UNITED STATES PATENT AND TRADEMARK OFFICE

10/823,777

Office Action Summary

DETAILED ACTION

Provided figure 1

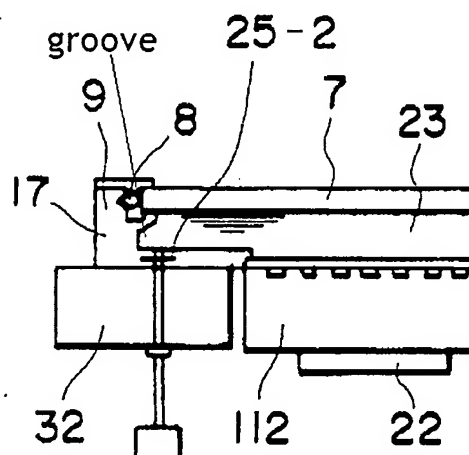
Regarding claims 4 and 21, Takahashi discloses “wherein the barrier (9, 17) comprises a groove (see provided figure 1 below, where groove is indicated) recessed into an upper surface of the substrate table (112).”

Regarding claim 5, Takahashi discloses “wherein the groove is sized such that the liquid (23) can be transported along the groove under capillary action (see fig. 2, where the liquid 23 can be transported and contained within groove showing in provided figure 1 above).”

Regarding claims 12 and 25, Takahashi discloses “wherein the barrier (9, 17) comprises a groove and a projection which projects out of an upper surface of the substrate table (see provided figure 1 above, where the element 17 is projected upwards from the substrate table with a groove).”
